# **Consideration of Geochemical Issues in Groundwater Restoration at Uranium In-Situ Leach Mining Facilities**

**U.S. Geological Survey**

**U.S. Nuclear Regulatory Commission  
Office of Nuclear Regulatory Research  
Washington, DC 20555-0001**

**Figure 12. Simulation 1 results. Oxic influent groundwater. Calcite and goethite initially present. Mass transfer coefficient = 10.**

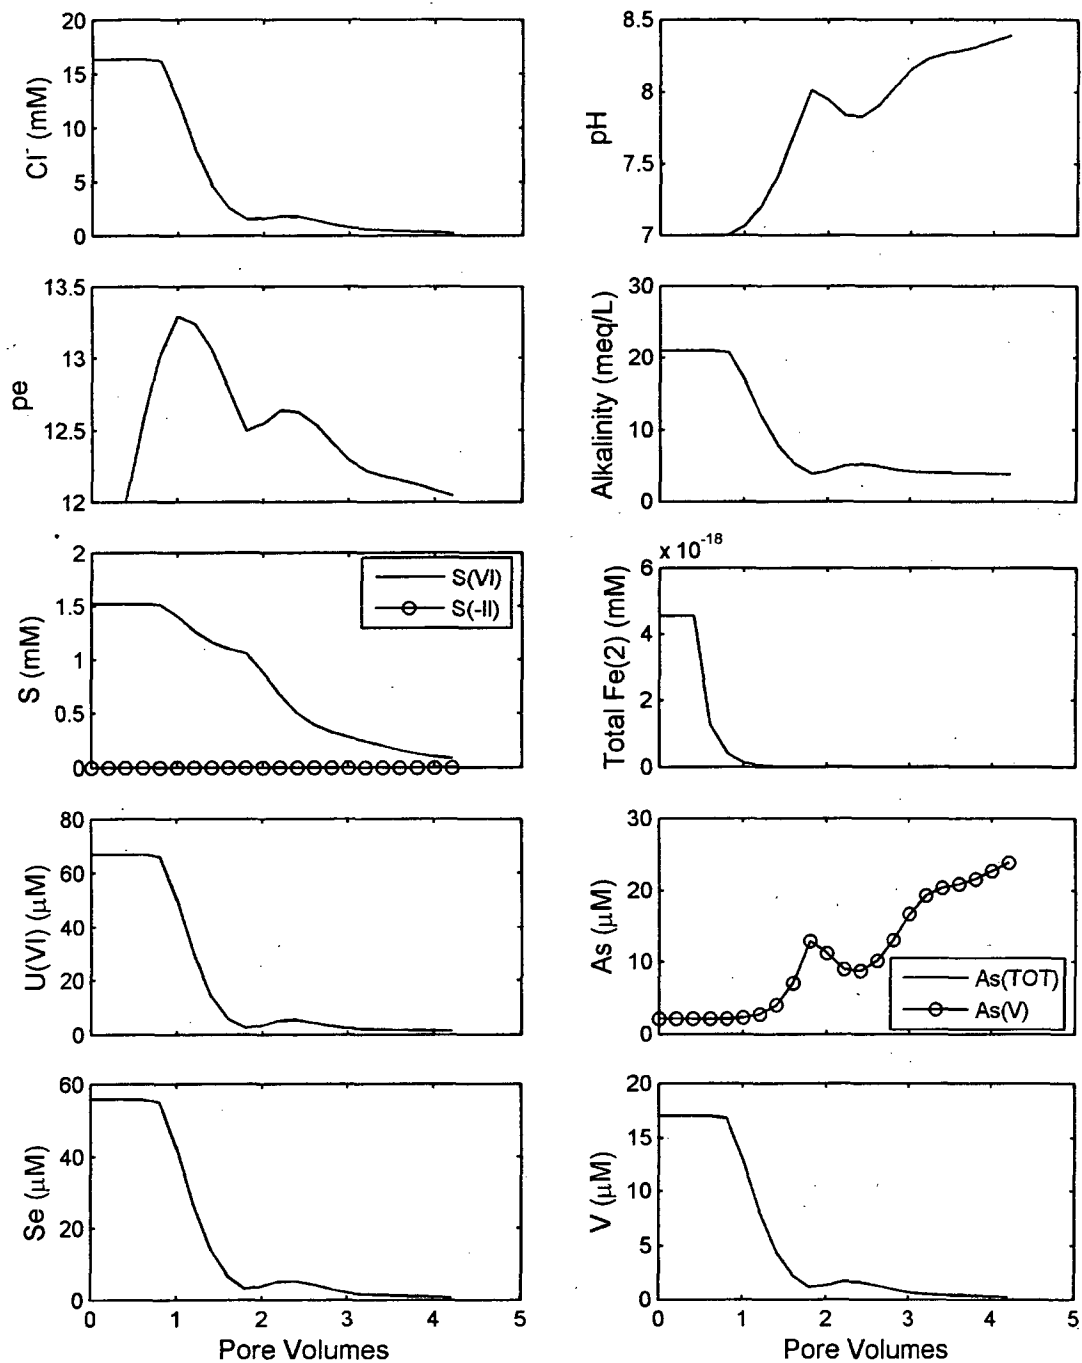
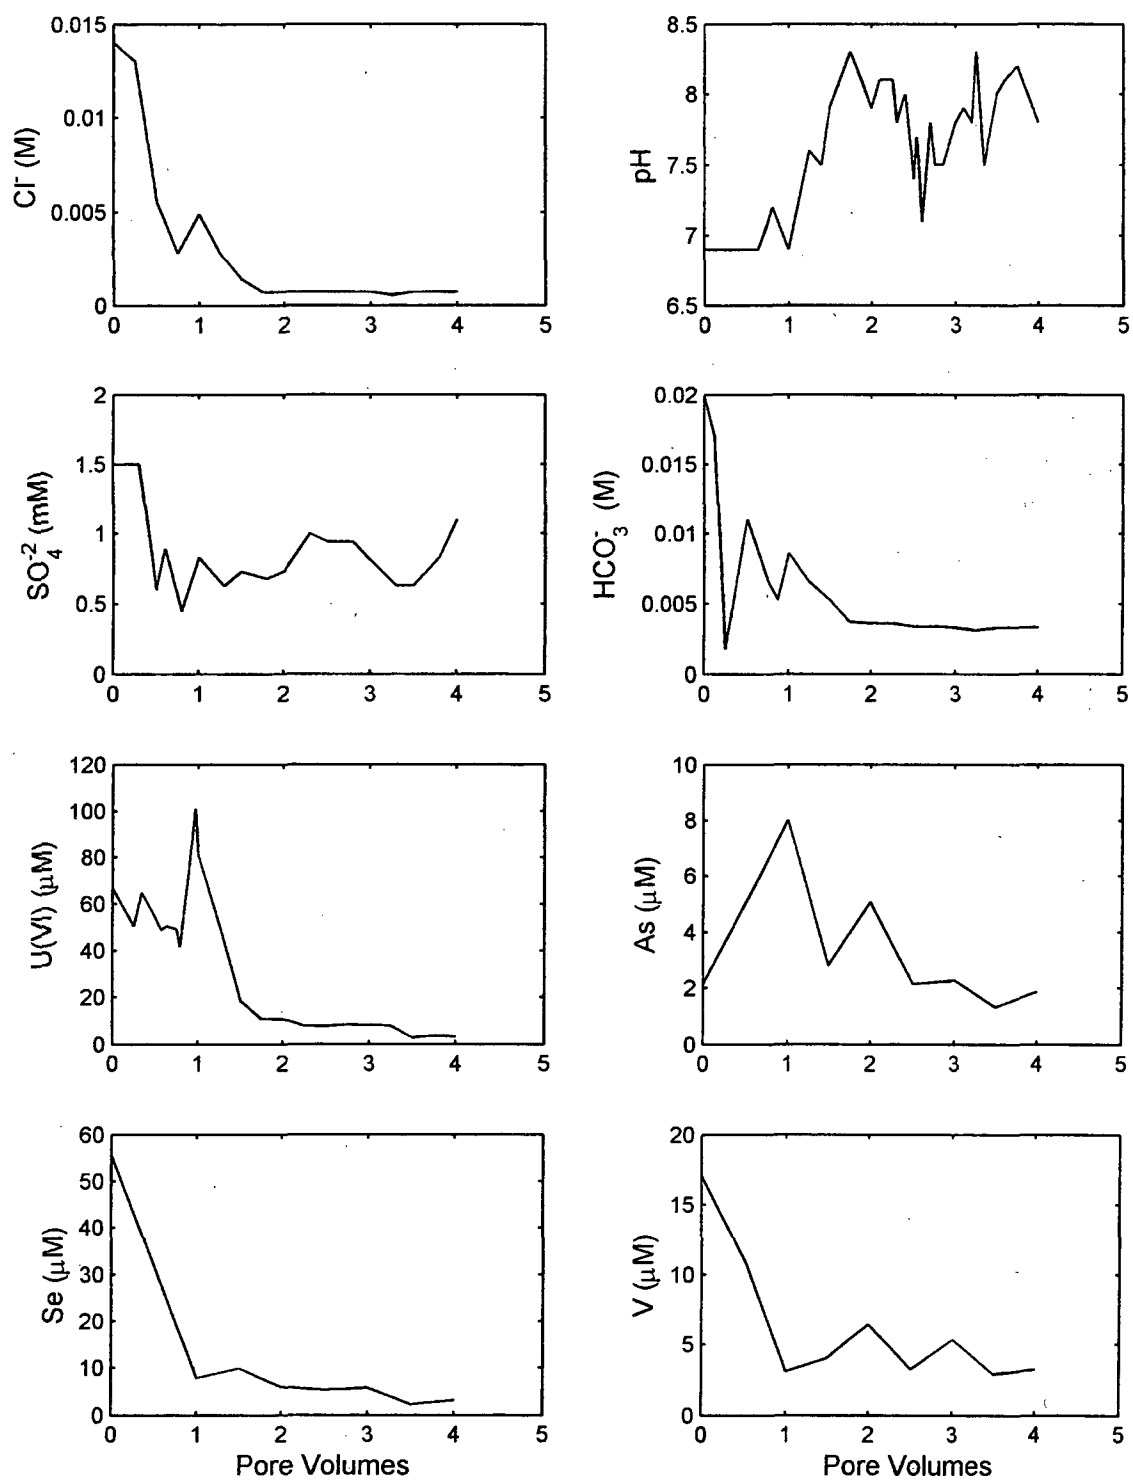
**2-16. Comment:** The results of Simulation 1 (Figure 12) are compared with the Ruth data (Figure 11). For illustrative purposes, it might be helpful to have another figure with the both the simulation results and the field data. Also, it would be helpful if the differences between the Ruth test and Simulation 1 were noted. For example, how many pore volumes were removed during ground water sweep during the Ruth test (and how was 'pore volume' defined for the Ruth test)?
